WILSON SCHOOL DISTRICT – PROPANE TANK ACQUISITION AND INSTALLATION
AND PROPANE SUPPLY

ADDENDUM NO. 2

Date: March 31, 2021

**TRANSPORTATION CENTER
FUEL TANK SITE PLAN**
C2C DESIGN GROUP
37 East Penn Avenue
Harrisburg, PA 17105
610.866.6636 www.c2cdg.com

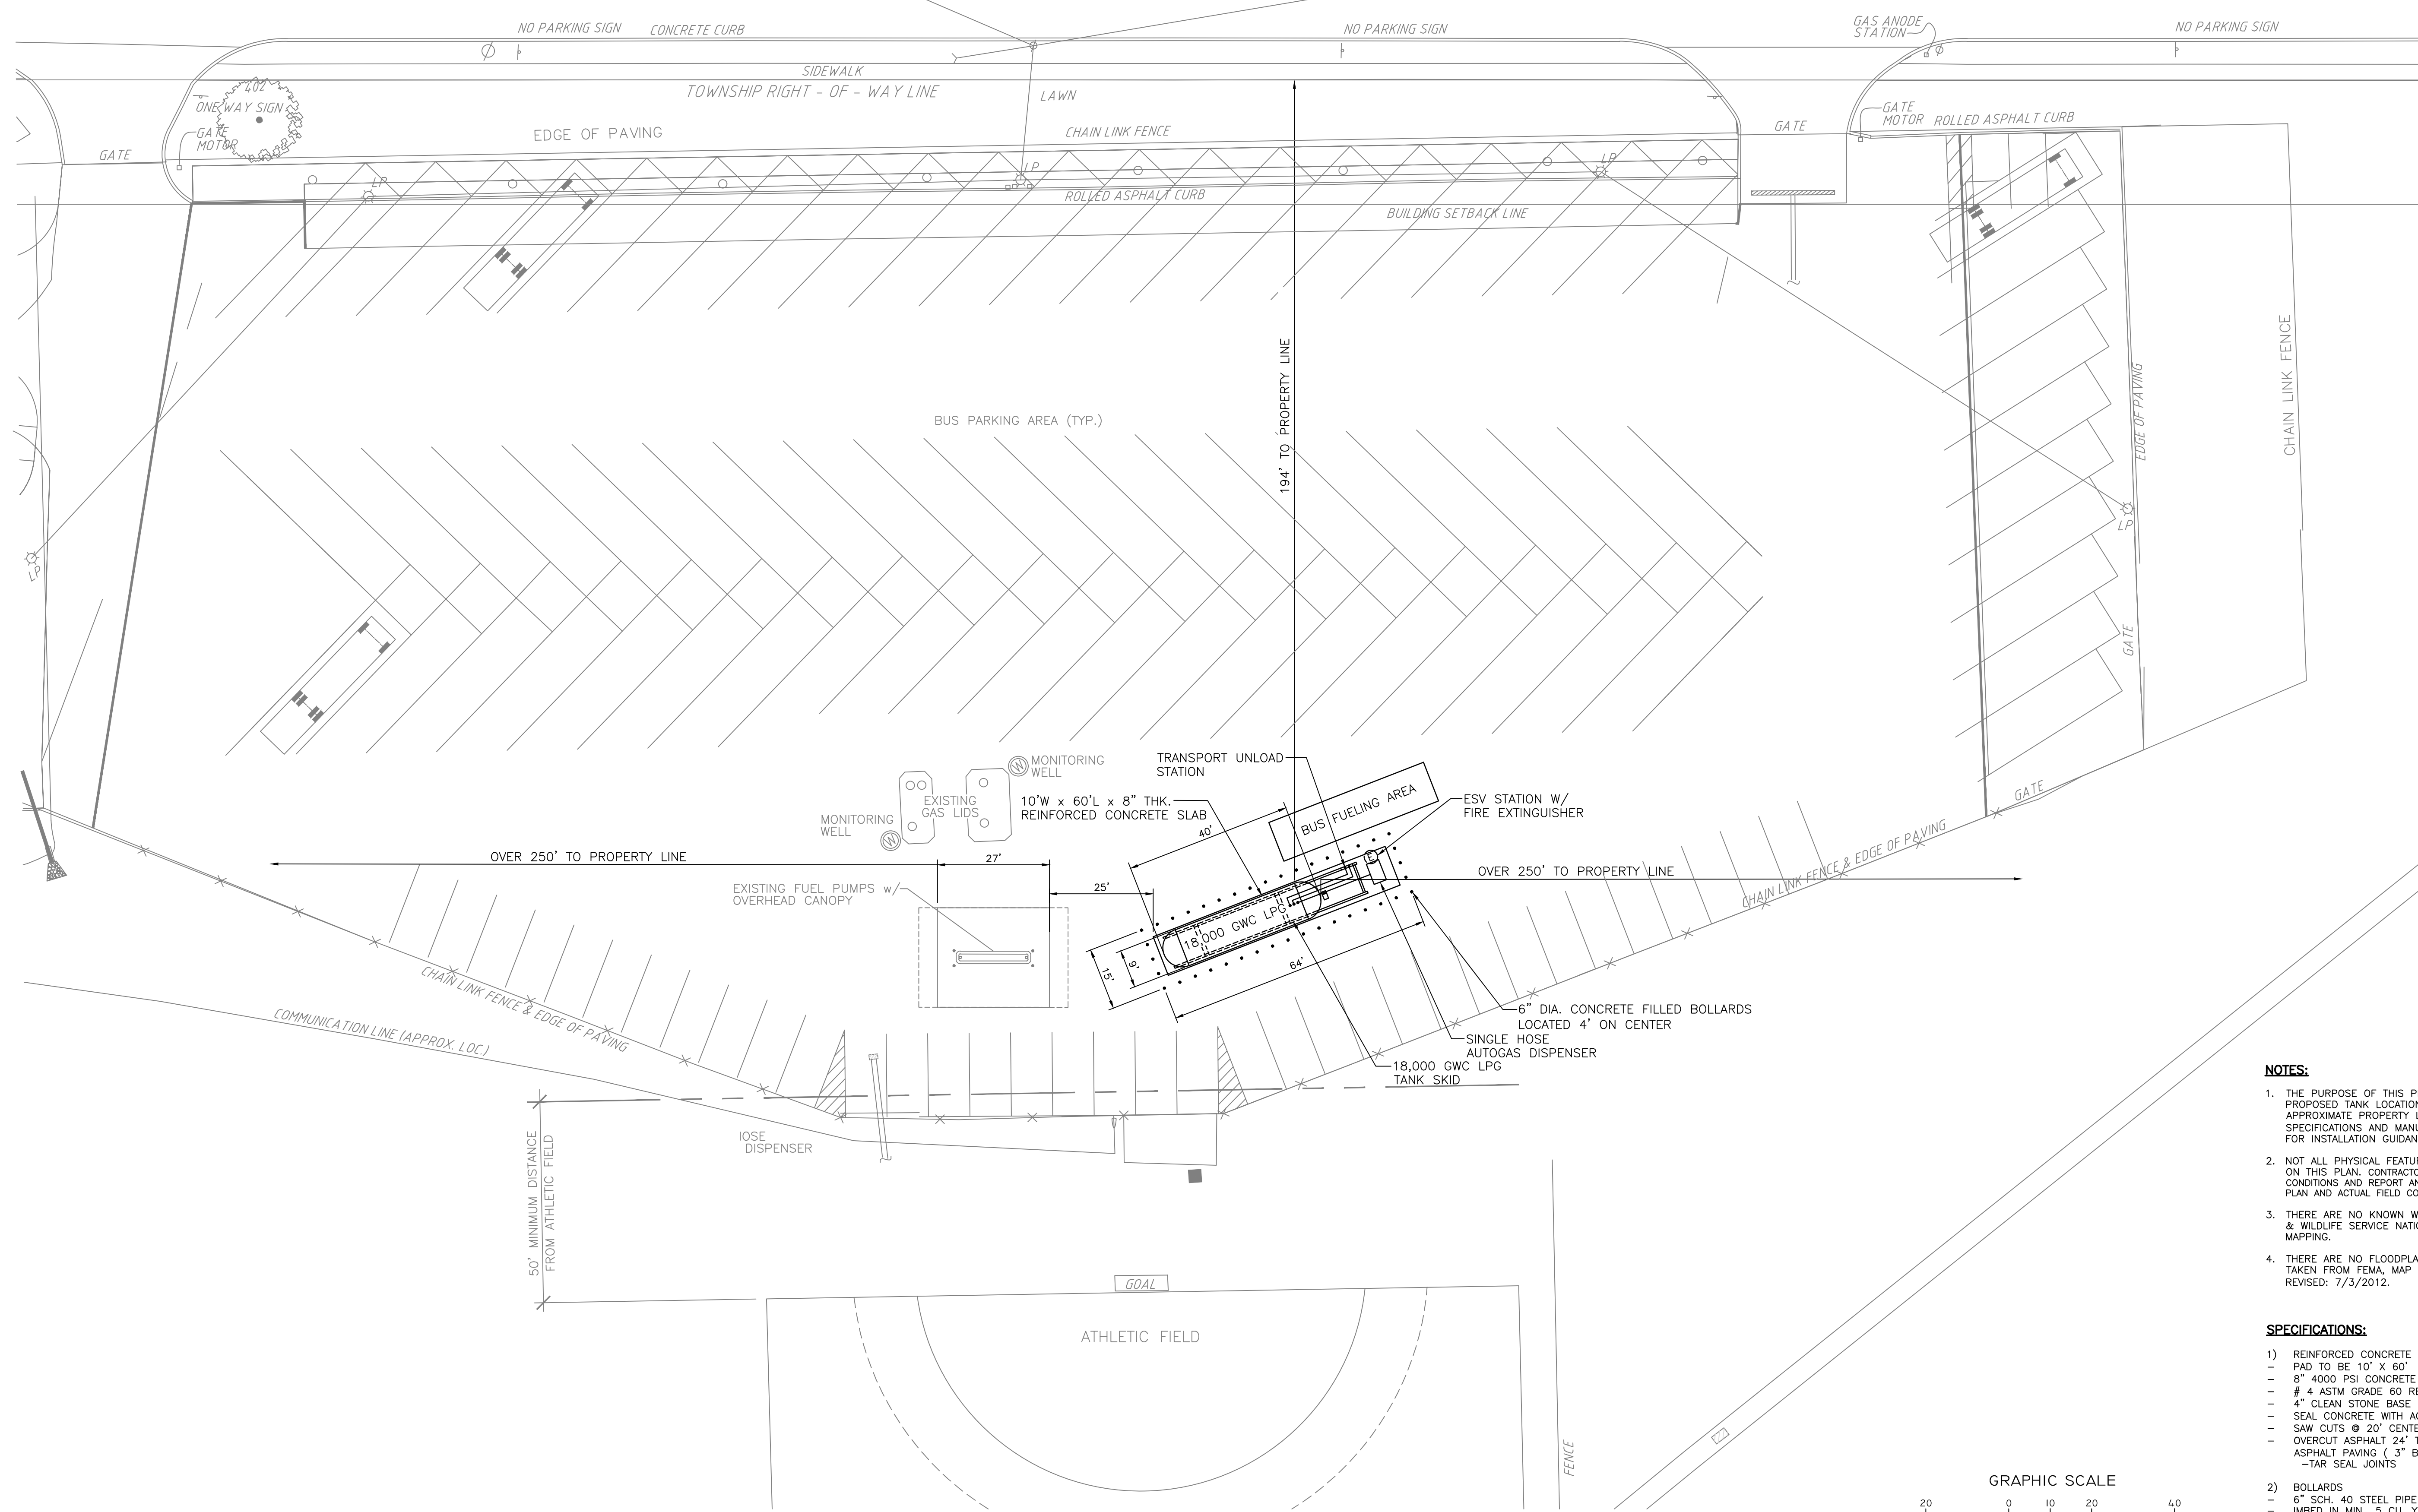
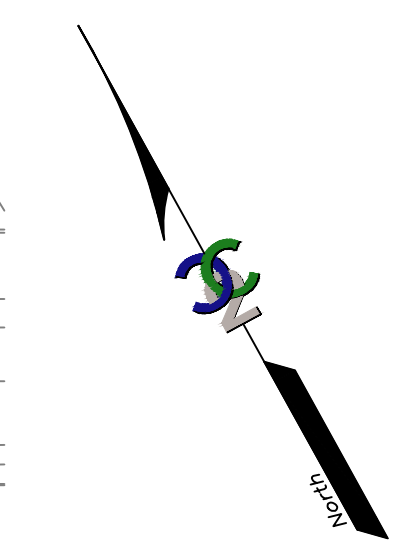
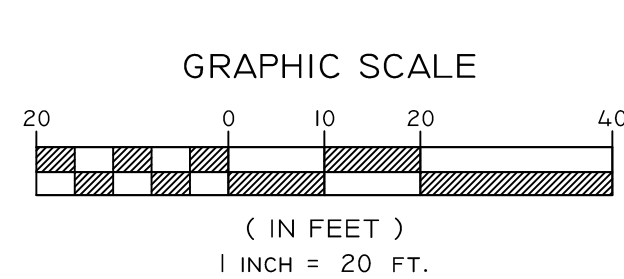
1. The Fuel Tank Site Plan, SP-1, included in the Bid Documents as Document No. 18 is removed and replaced with the enclosed Fuel Tank Site Plan, SP-1. The revised site plan clarifies that the existing point of transfer (other fuel pumps) and the new propane storage tank are separated by a distance of 25 ft.

REV. NO.	DATE	DESCRIPTION
1	3/31/21	REVISED TANK LOCATION
